PLANNING TECHNICAL REVIEW COMMITTEE –AGENDA

TECHNICAL REVIEW COMMITTEE MINUTES - P18-25

Application Type: Site Plan Review
Applicant(s): First Street at Garrison, LLC
Owner(s): First Street at Chestnut, LLC
Location: First Street (Tax Map 6, Lots 3-1 and 9)
Date: June 28, 2018

SHEET 4

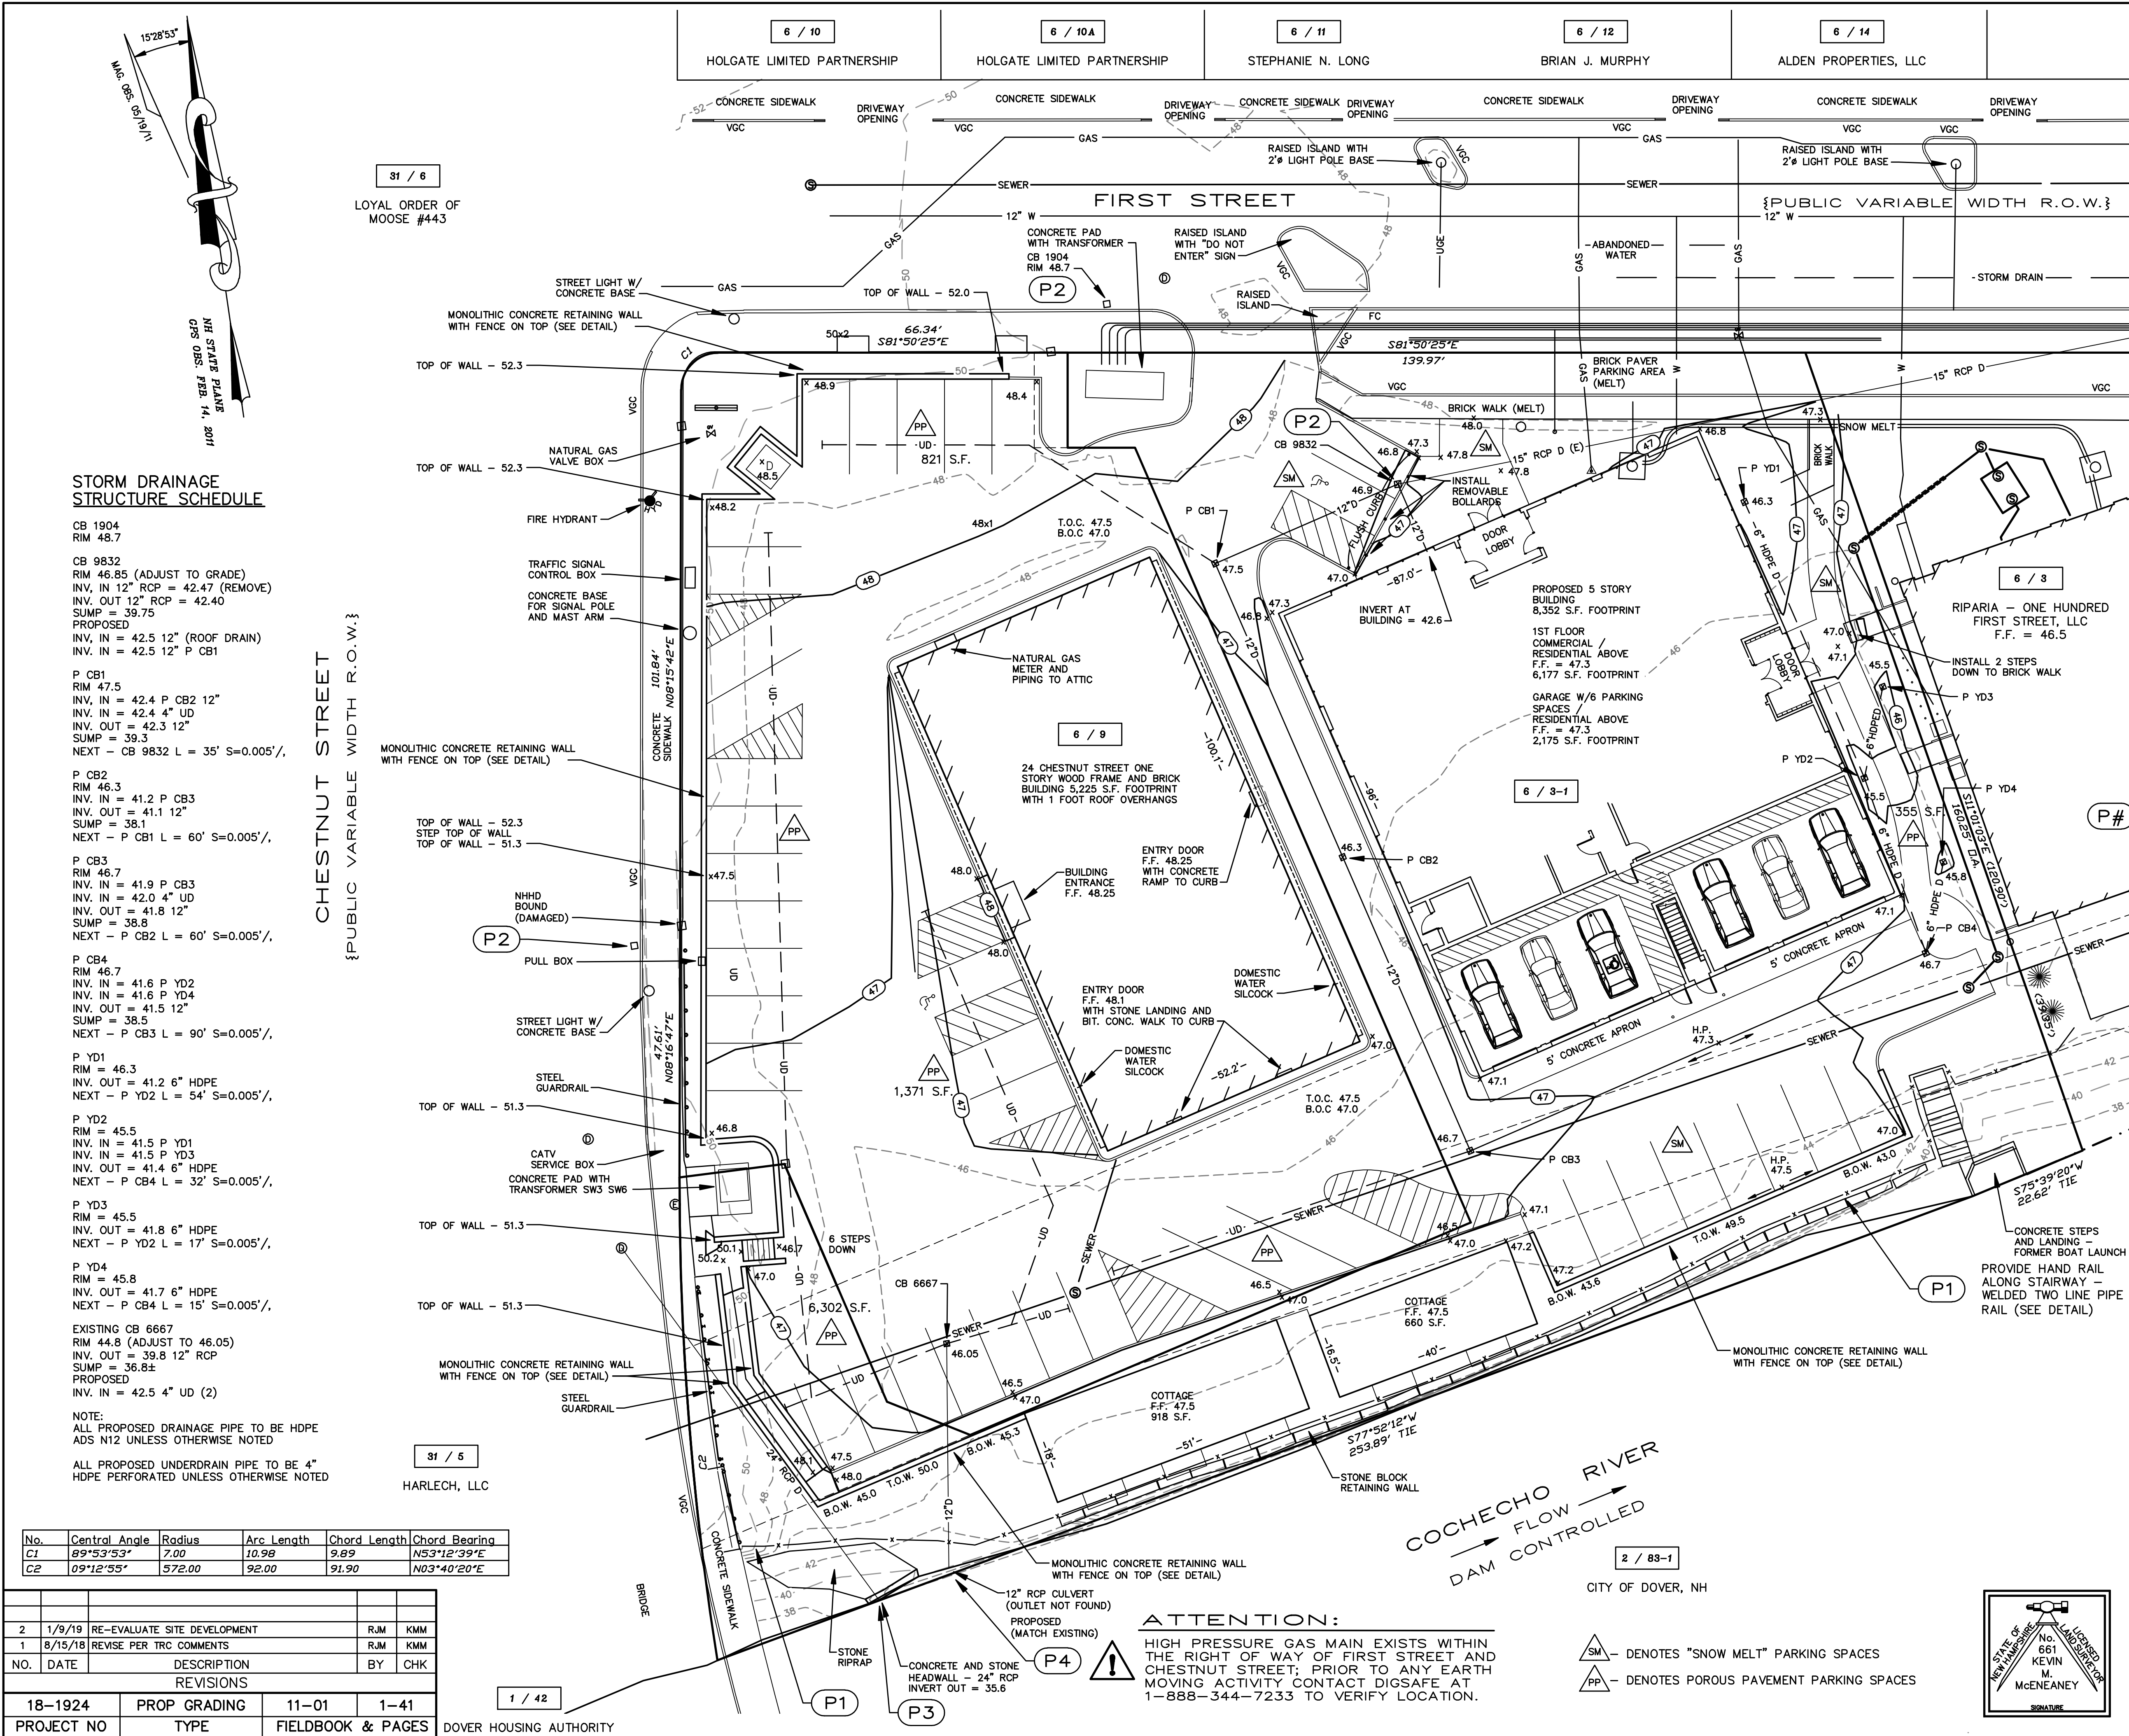
- Indicate accessible parking spaces w/ accessible routes
- Clarify:
 - Distance from existing one structure to proposed five story adjacent structure and parcel boundaries (sheet 4)

SHEET 7

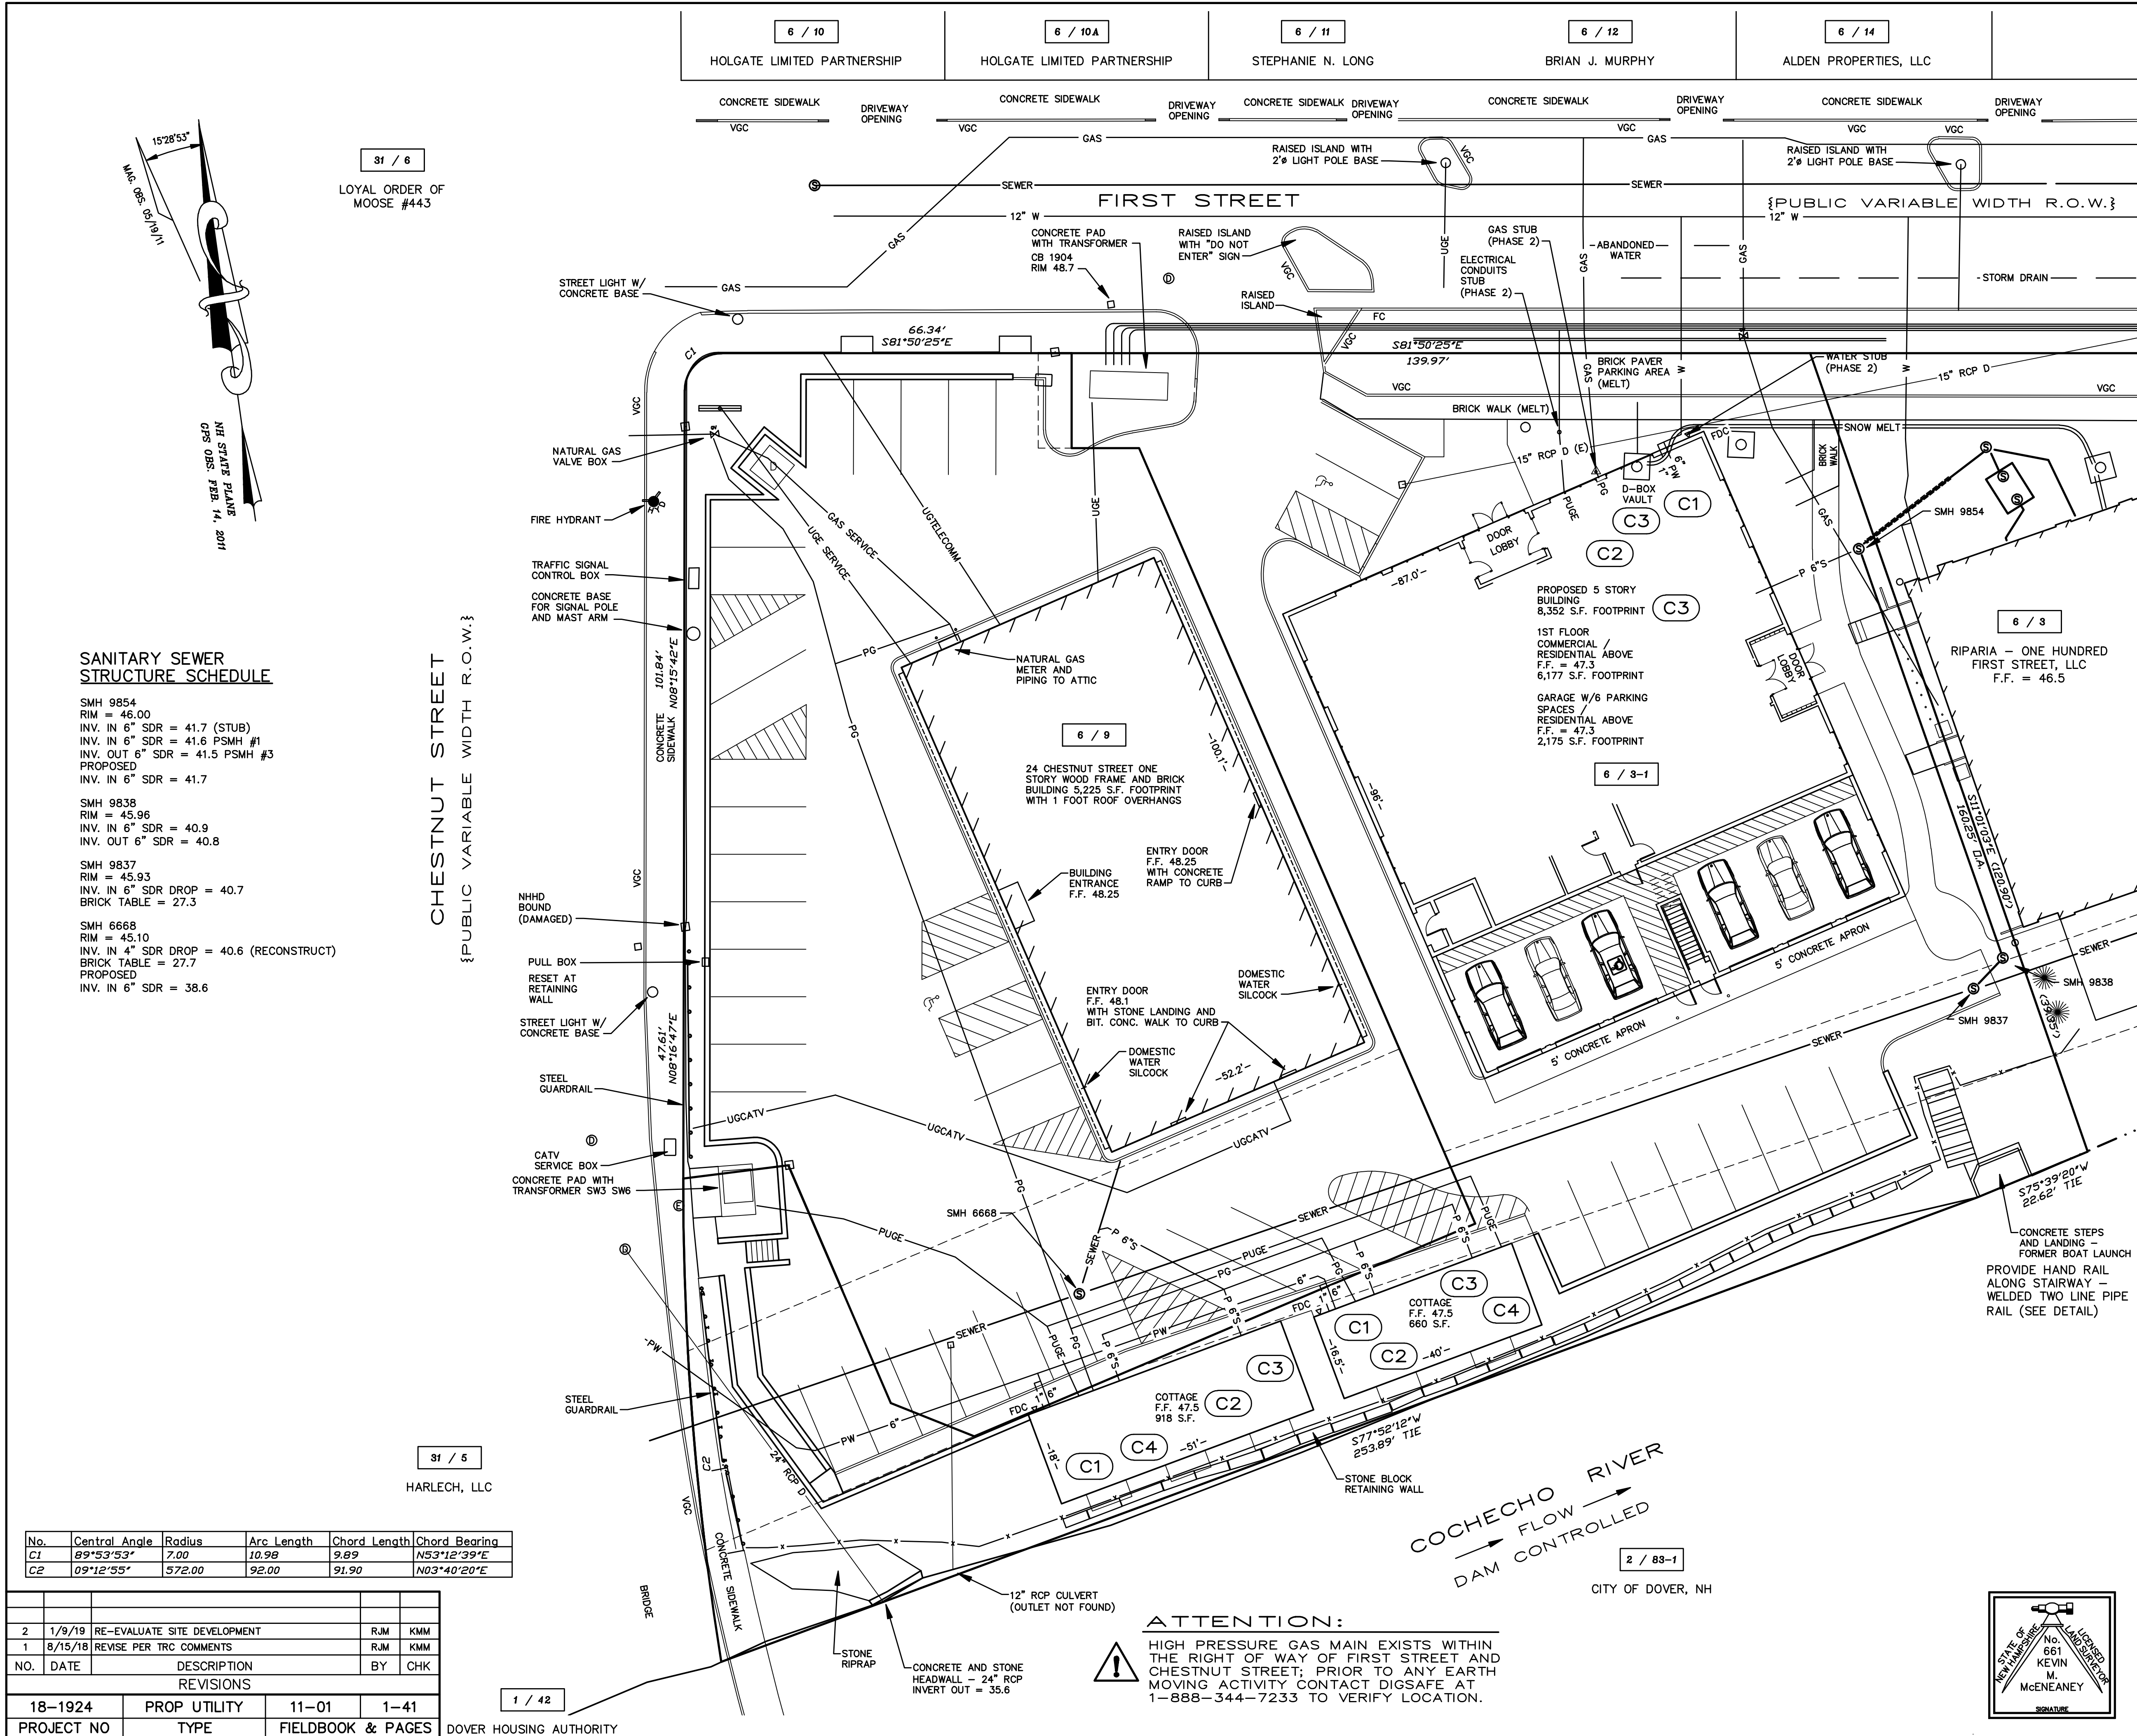
- Sheet 6:
 - Clarify domestic water and sprinkler supplies to the proposed structures.
 - Clarify UGE to structures
 - Clarify gas to the two cottage buildings along the water
